Work Order ID 81812

Item Name: Crosstube Turning Detail

DART AEROSPACE LTD		Work Order:	81812
Description: Crosstube Assembly (205/212/412 High Fwd)		Part Number:	D212-664-141
Inspection Dwg: D212-664-141 Rev: D		Page 1 of 1

DRAWING NO. D212-664-141	TITLE XTUBE ASSY (205/212/412 HI FWD)	REV. D	DART AEROSPACE LTD ENGINEERING ORDER		D.E.O. NO. D212-664-141-D-1	SHEET NO. SHEET 1 OF 2	SCALE NTS
DRAWN	CHECKED	MFG. APPR.	APPROVED	DE APPR.			
DATE 11.04.07	DATE 11.04.11	DATE 11.04.12	DATE 11/04/12	DATE 11.04.12

**D212-664-141/-141B
ASSEMBLY DETAIL**

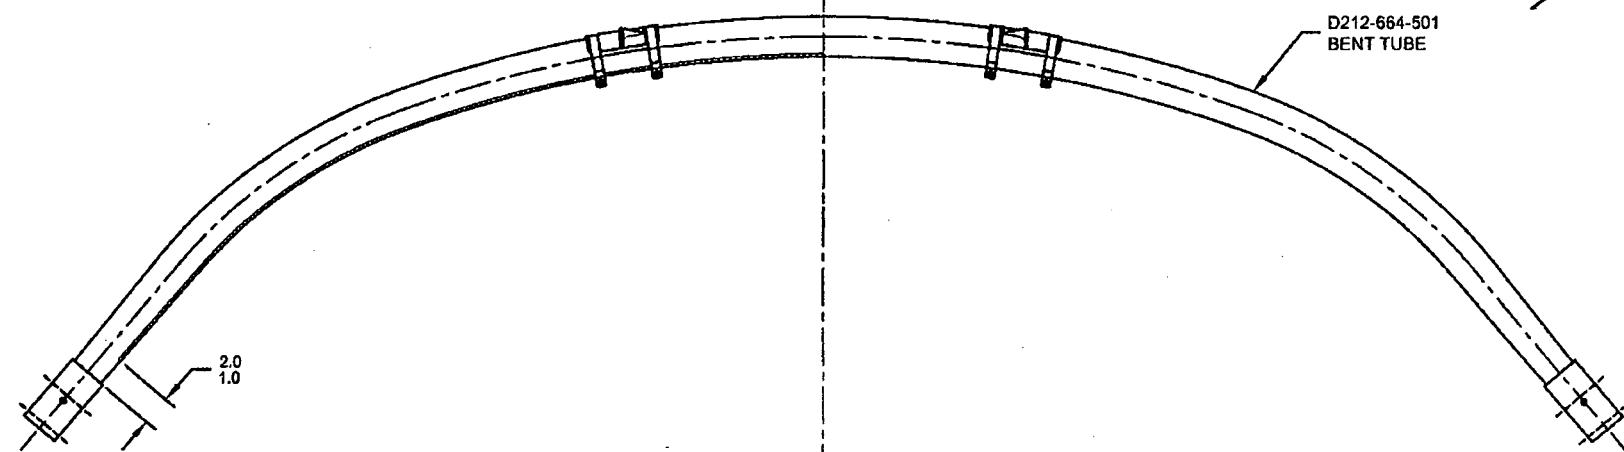
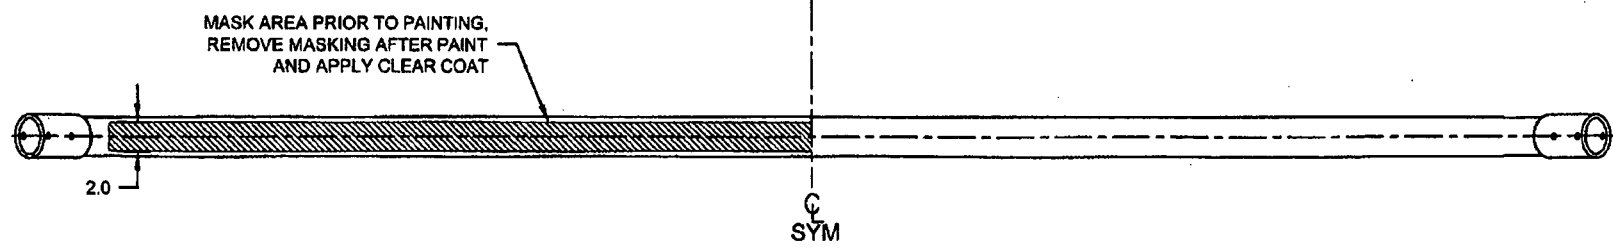
PURPOSE:

ADD AN INSPECTION WINDOW TO UNDERSIDE OF CROSSTUBE.

NOTES 2 OF SHEET 1 IS AMENDED AS FOLLOWS:

IS:

- 2) FINISH: CHEMICAL CONVERSION COAT PER DART QSI 005 4.1
PRIME INSIDE AND OUTSIDE PER DART QSI 005 4.2
MASK UNDERSIDE OF CROSSTUBE AS SHOWN (HATCHED AREA) AND
PAINT OUTSIDE PER DART QSI 005 4.2
REMOVE MASKING AND APPLY CLEAR COAT

WAS:

- 2) FINISH: CHEMICAL CONVERSION COAT PER DART QSI 005 4.1
PRIME INSIDE AND OUTSIDE PER DART QSI 005 4.2
PAINT OUTSIDE PER DART QSI 005 4.2
